**SUBJECT:** NuScale Power, LLC Response to NRC Request for Additional Information No. 361 (eRAI No. 9285) on the NuScale Design Certification Application

NuScale Response to NRC Request for Additional Information eRAI No. 9285

**NRC Question No.:** 12.03-41

**NRC Question No.:** 12.03-42

Figure 11.4-2a: Process Flow Diagram for Wet Solid Waste  
Air Sparging Operation

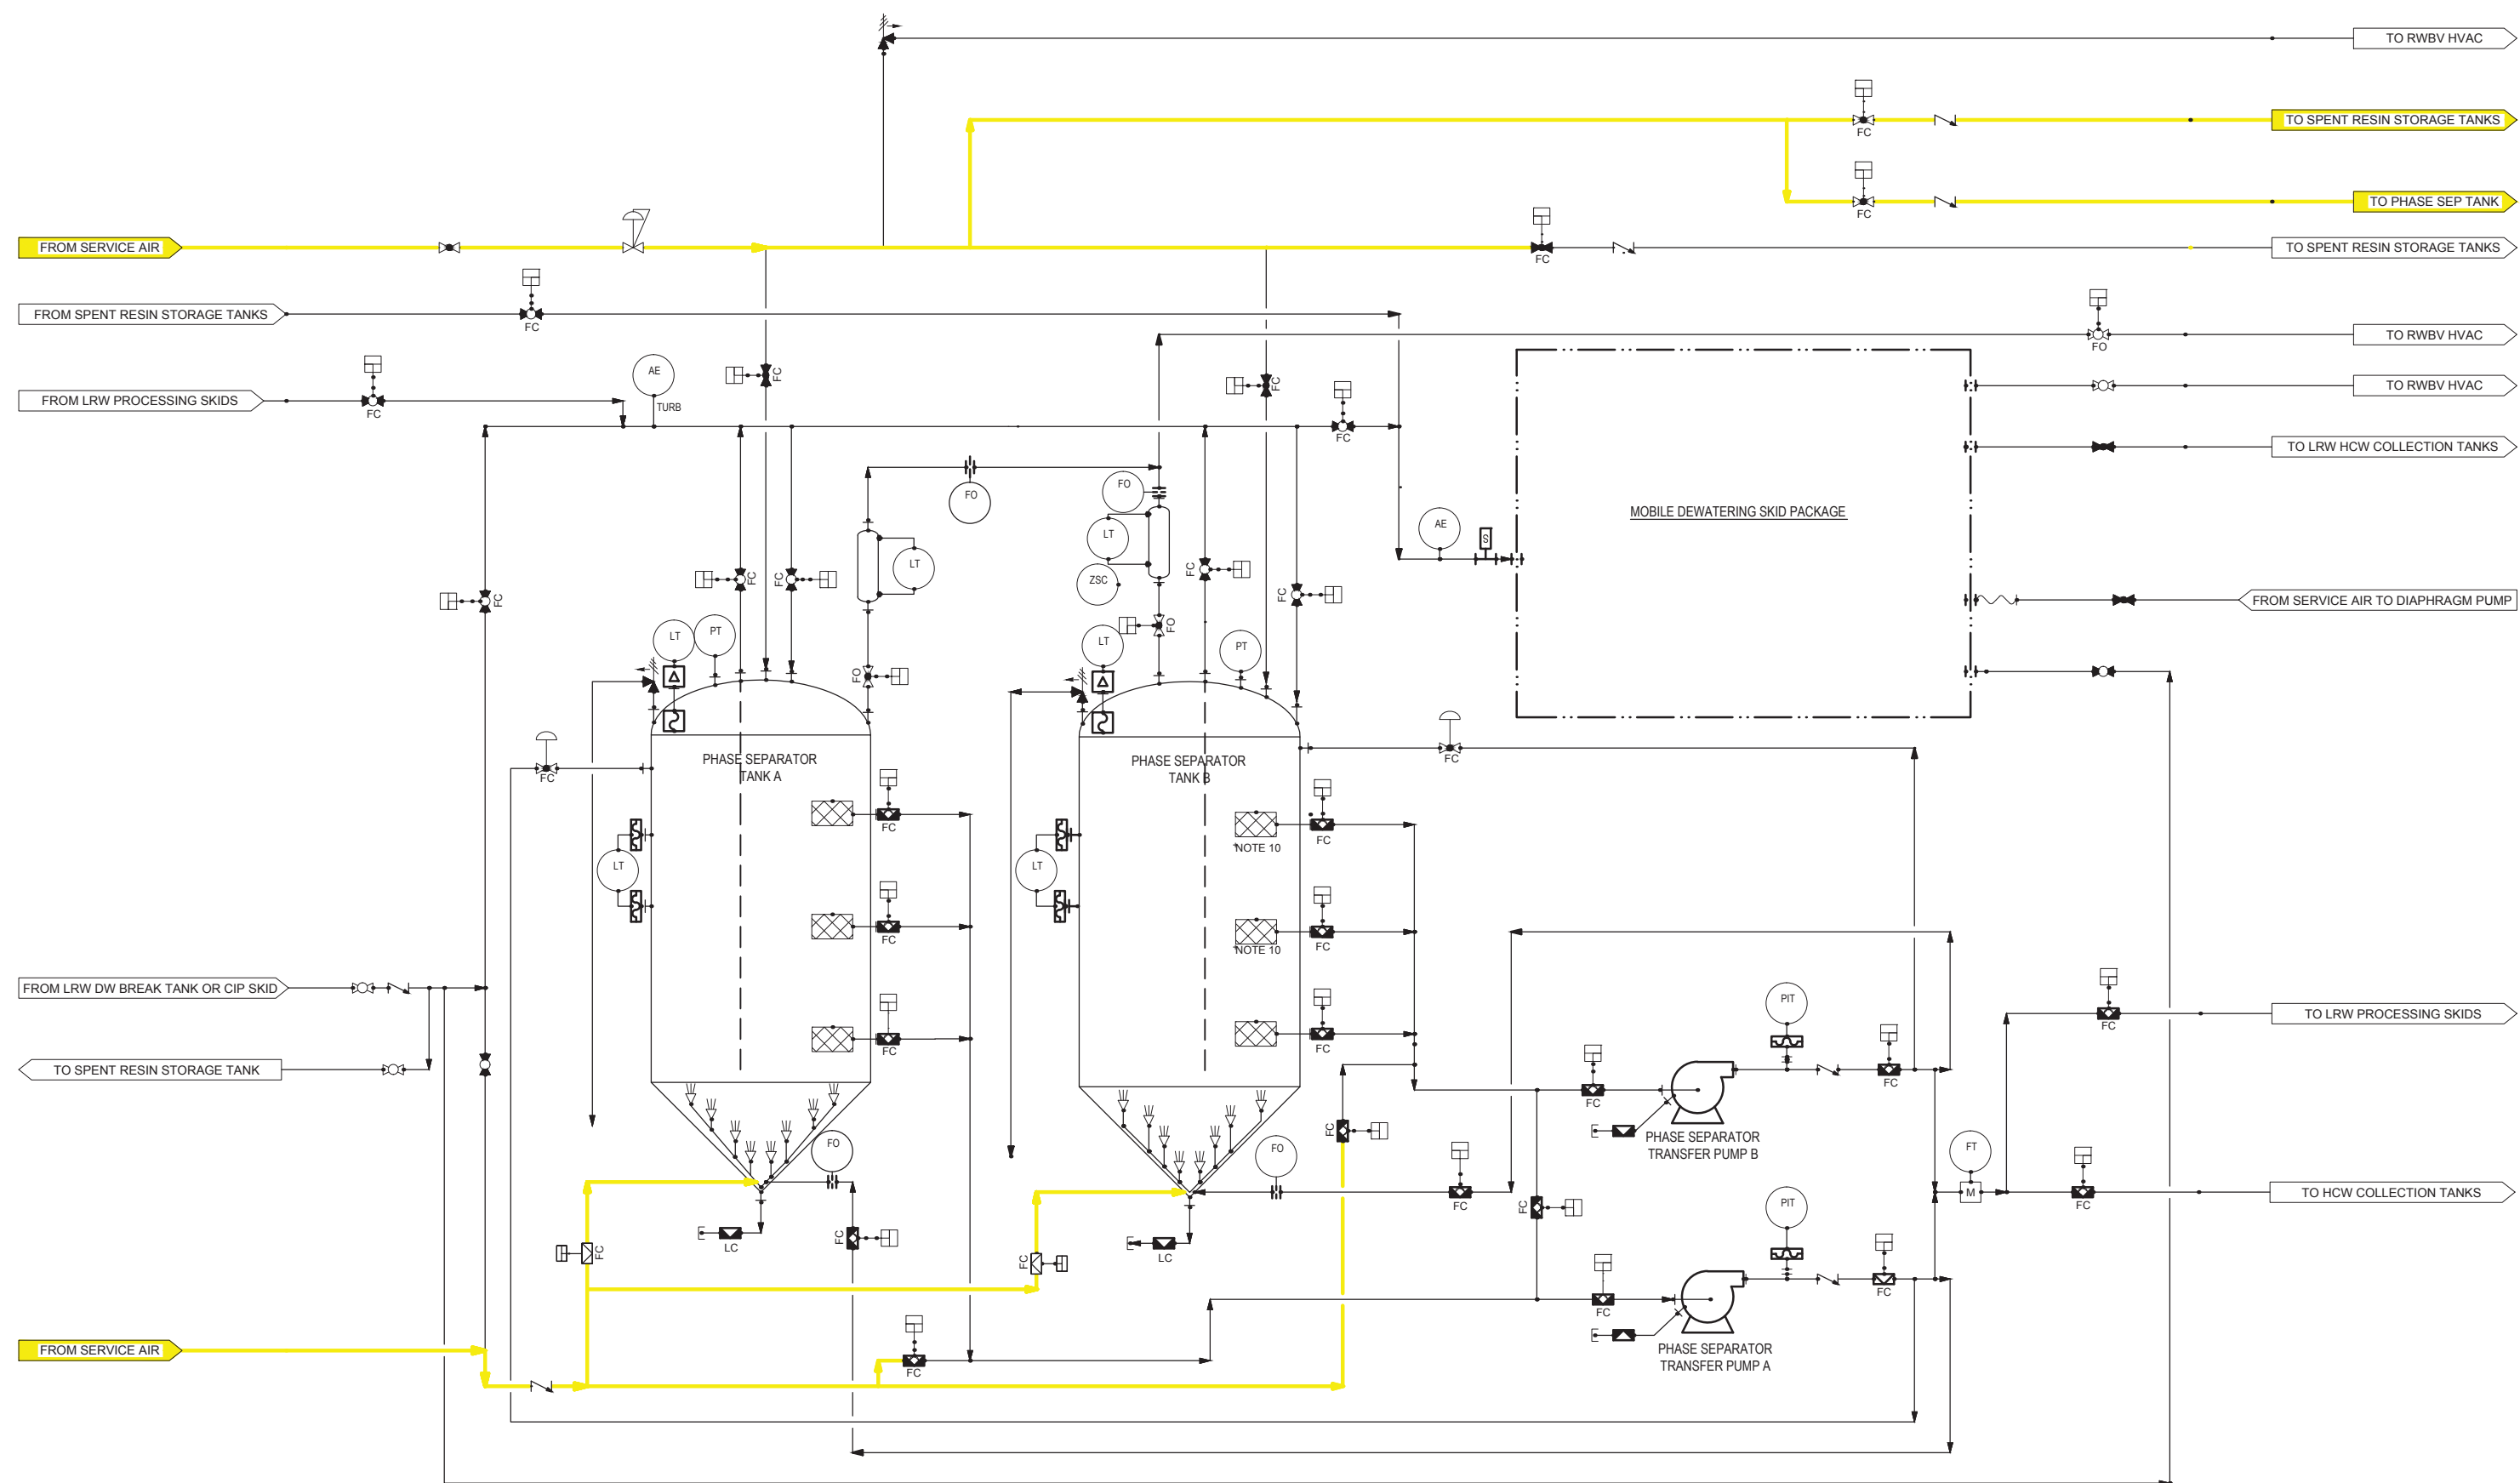
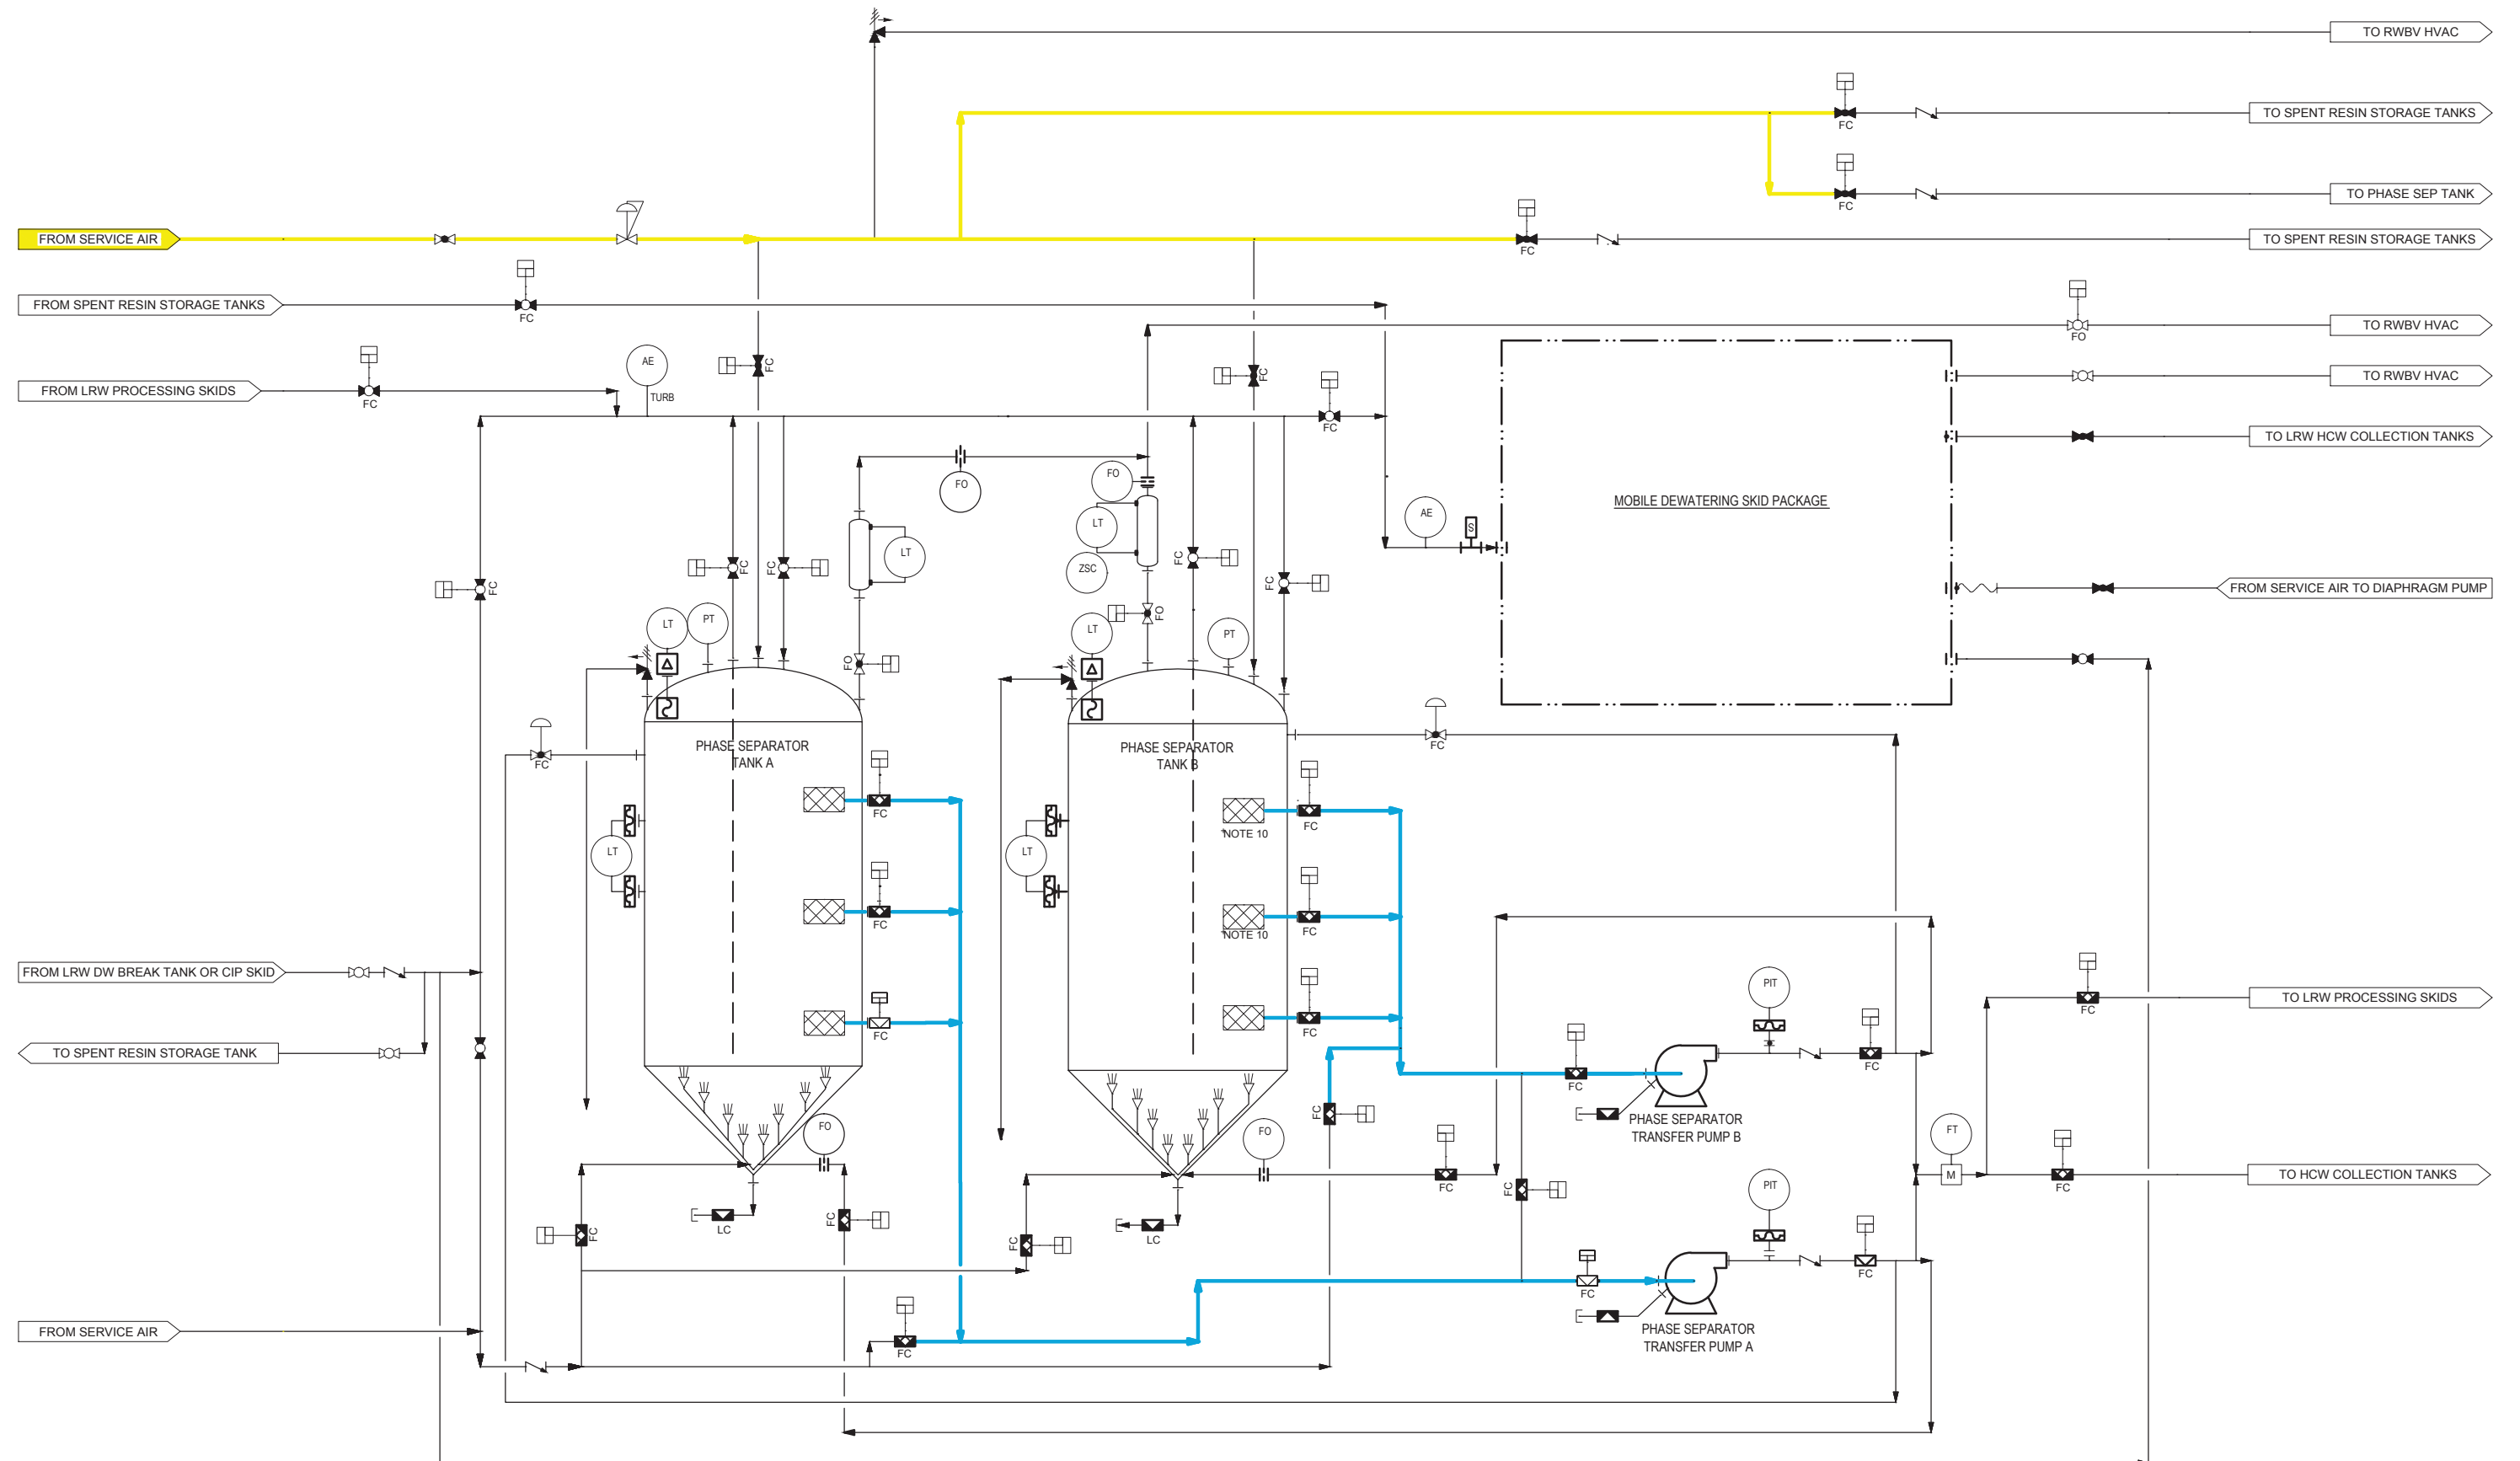
DCD Figure 11.4-2a: “Process Flow Diagram for Wet Solid Waste,” and DCD Figure 11.4-2b:

“Solid Radioactive Waste System Diagram,” show a line from the Service Air system that is separated from the suction of the resin transfer pumps by a single isolation valve. The use of a single isolation valve increases the risk for air intrusion due to valve leakage or misalignment. Based on information made available to the staff during the RPAC Chapter 12 Audit, the suction isolation valves for the pumps appear to be diaphragm disk valves. This information appears to be consistent with DCD Section 11.4.2.5.3, “Piping and Valves,” which states that valves in slurry transfer lines are full-ported ball valves and liquid process valves are diaphragm valves. Operating experience is available (e.g., Electric Power Research Institute (EPRI) Technical Report (TR) 105852 Volume 1 “Valve Application, Maintenance, and Repair Guide,” ) to the staff that indicates that leaks past seats of these types of valves can occur as a result of poor stem travel adjustment, diaphragm age and over setting the stem travel. Typically, these types of valves are not in a periodic performance testing (i.e., leakage testing) program, and the staff has not seen any information that indicates that they are in a performance testing program.

To prevent air intrusion into the SRWS transfer pumps, the service air is isolated from the suction side of the transfer pumps by at least two valves. To illustrate the separation of service air from the transfer pump suction, FSAR Figures 11.4-2a and 11.4-2b are annotated with yellow and blue colored lines to show the system configurations during an air sparging operation and a transfer pump operation.

For the air sparging operation figures, the yellow colored lines indicate the pipes that will be filled with service air during an air sparging operation. It can be seen that there are two isolation valves between the service air and the transfer pump suctions. This mode of operation is expected to be infrequent.

Similarly, for the transfer pump operation figures, the blue colored lines indicate the pipes that will be filled with decant water during a transfer pump operation, and the yellow colored lines still indicate pipes filled with service air. The pump transfer operation figures show there are at least two isolation valves between the service air and the transfer pump suctions.
